To: Elmwood Planning Commission
From: Sarah Clarren, Planner / Zoning Administrator
Date: 8/14/24
RE: SPR/SUP 2024-05, Farm Club Expansion (2)

PLANNING COMMISSION
FINDINGS OF FACT, DECISION AND ORDER
SPR/SUP 2024-05, Farm Club Expansion (2)

Re: Farm Club Site Plan Amendment

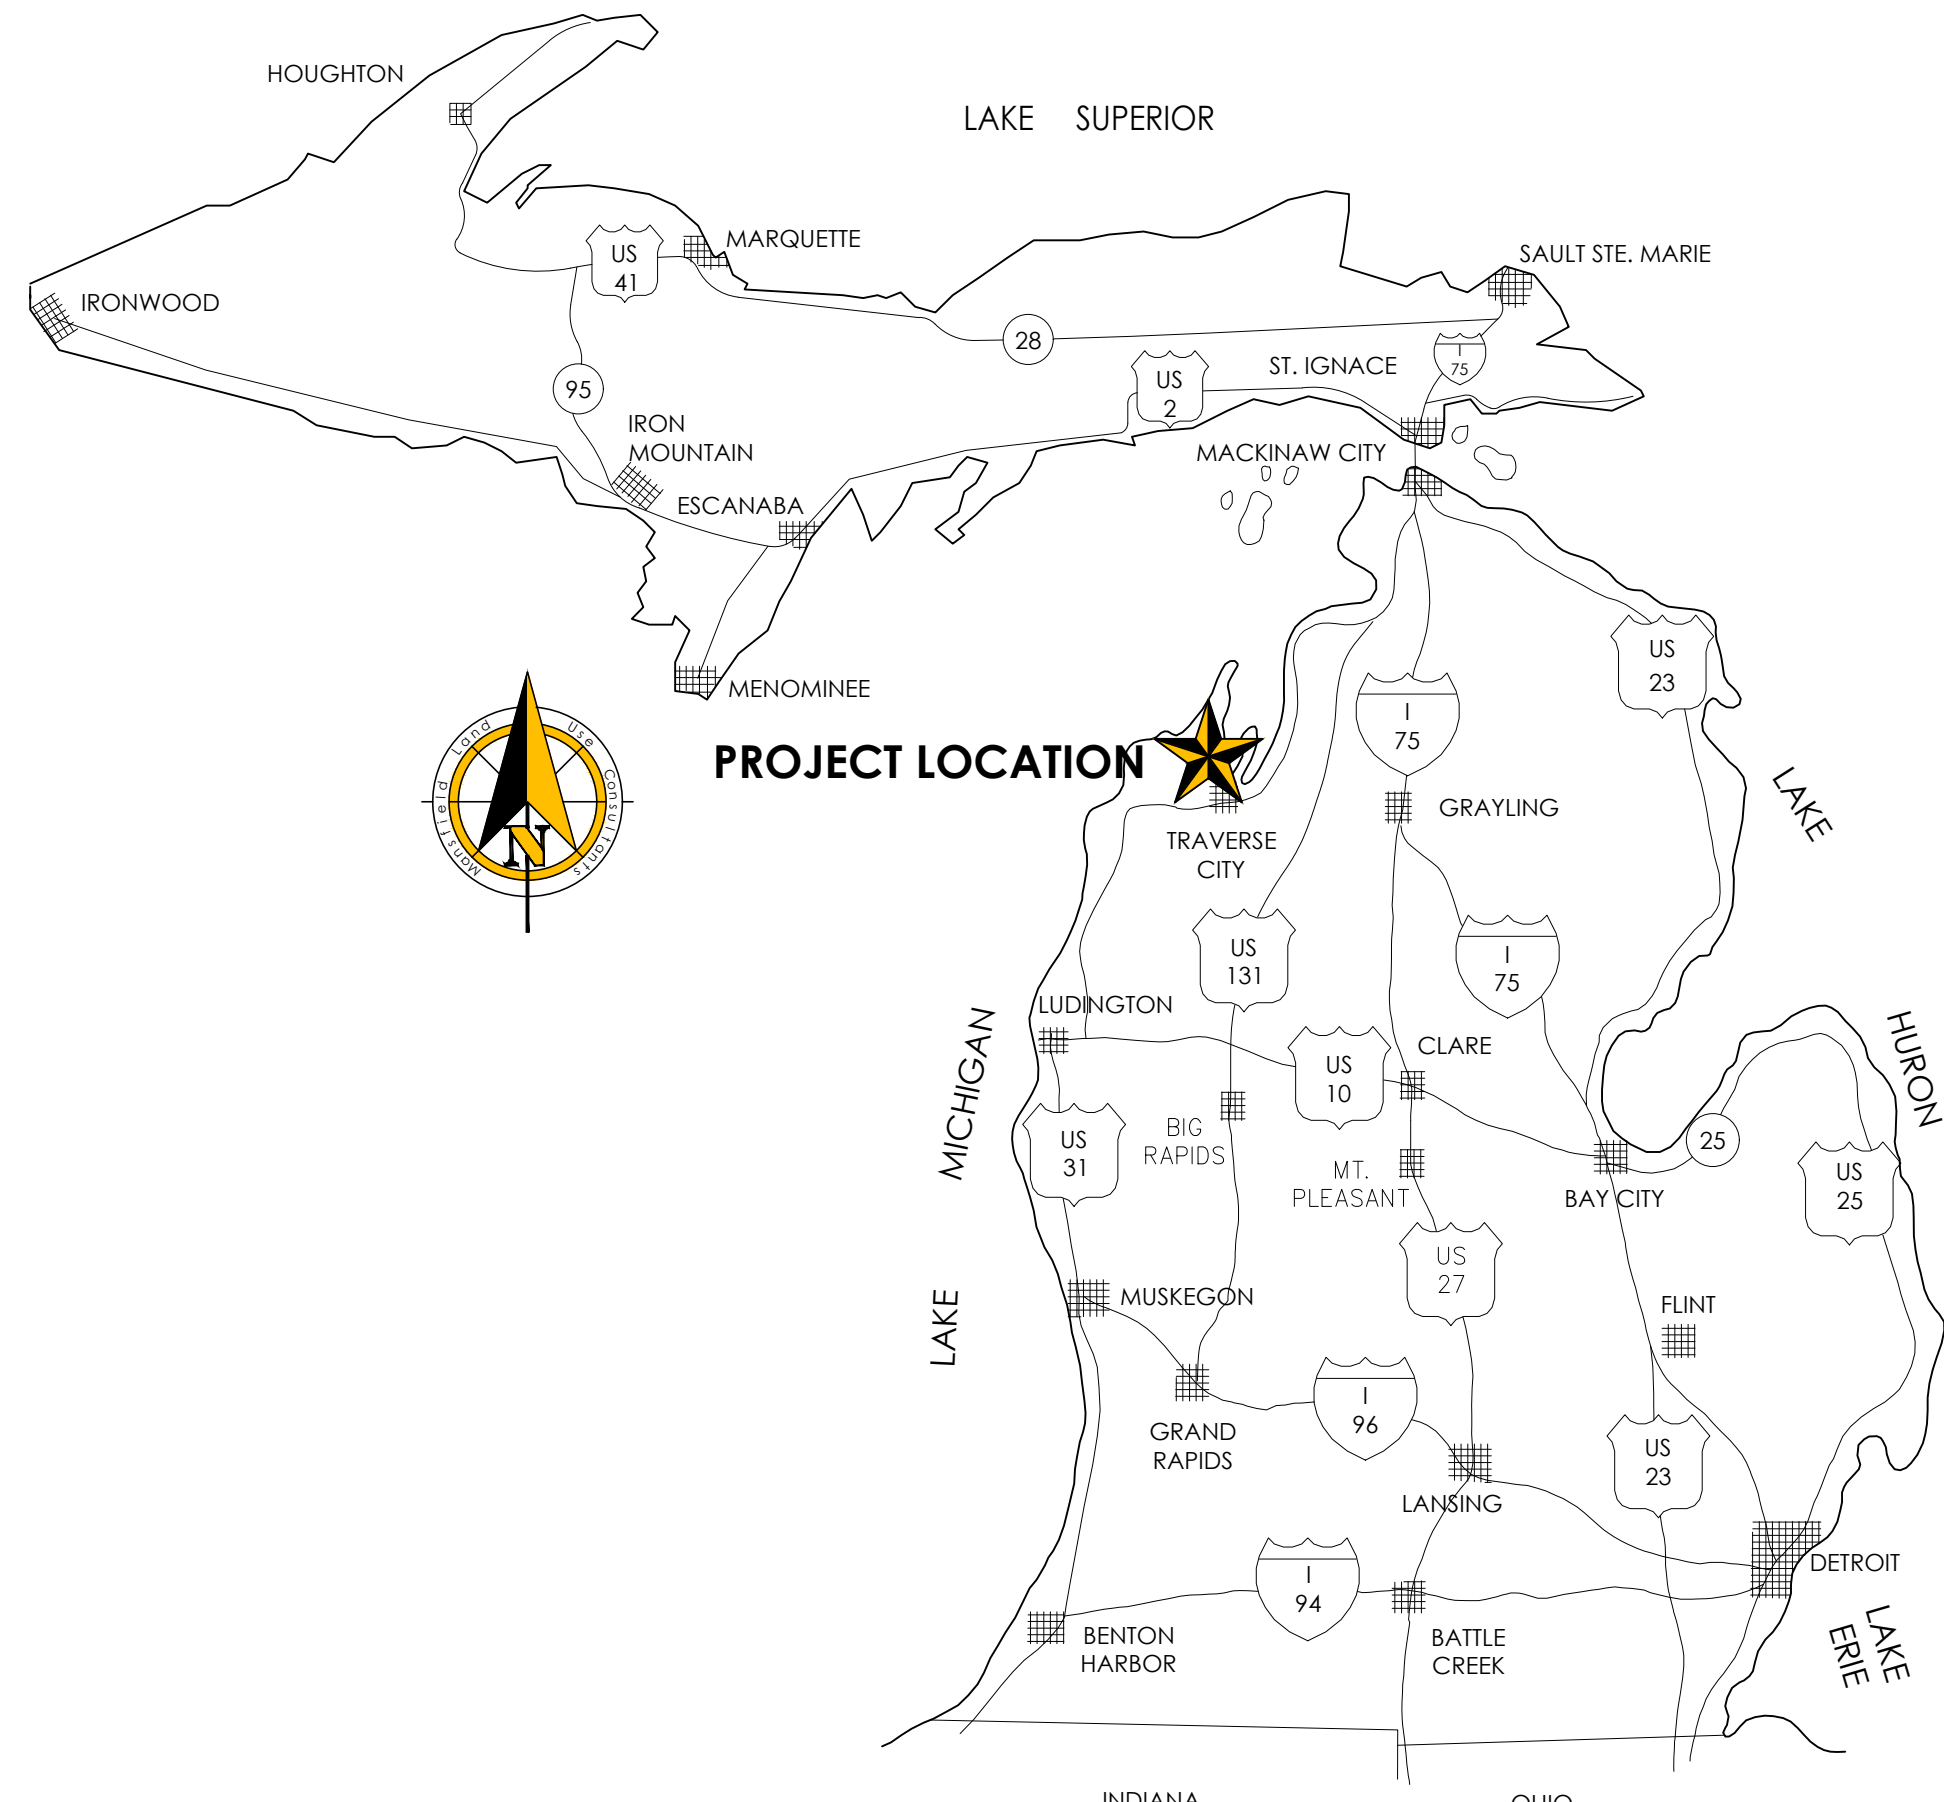
- b. Applicant shall provide address identification visible from the public right-of-way and at other approved locations to facilitate emergency response. Address identification and approved locations will comply, at a minimum, with IFC standards. *Reference: IFC 505.1.*

- c. Applicant shall maintain clear access to the existing on-site fire suppression water tank and dry hydrant located along the southern edge of the existing north parking lot (next to the existing main building). *Reference: IFC 507.5.4.*

- d. Applicant shall place and maintain signage designating “NO PARKING – FIRE LANE” along the main driveway up to the entrance of the furthest parking area and in front of the water tank’s dry hydrant. Signs shall be conspicuously spaced to discourage parking in these areas. Signage should substantially meet the IFC Appendix D Fire Apparatus Access Roads – Section D103.6: Signs. Any proposed alternatives to the standard shall be approved by the Fire Chief. *Reference: IFC 503.3 & D103.6.*

- e. Applicant should create and maintain a drivable surface leading to within a minimum of 150 feet of the lawn seating area. The surface may be dirt, gravel, or grass but capable of sustaining the weight of smaller response vehicles (up to 20,000 lbs.) The drivable surface should include enough reasonable area to affect a turn-around and its location reported to the Fire Chief.

PRELIMINARY
 PXL: dmc
 DR: mm
 CDD: dmc
 CRKATD: 17.06.12
 JOB NO.: 17113
 L1.0

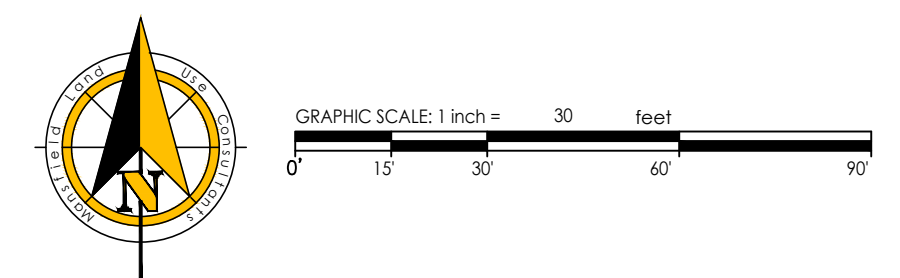
7. Landscaping shall comply with Section 6.4 including buffering requirements. ***Plan provided, but still does not meet the requirements of Section 6.4.3.A of the Ordinance. Can be made a condition of approval.***

32. Location and specifications for all fences, walls, and other screening features, with cross sections shown. ***Location of vegetated buffer shown (L1.0), dumpster screening and planting detail (C1.1). Note that buffering on plan still does not meet the requirements of Section 6.4.3.A of the Ordinance. Can be made a condition of approval.***

- D. Sheet L1.0 (last rev. 8/16/23) shows proposed parking screening as well as existing screening onsite. This screening does not meet buffer requirements of the Zoning Ordinance (Sec. 6.4.3 and 6.4.4).
- E. The Applicant has agreed to submit a revised plan meeting buffer requirements.
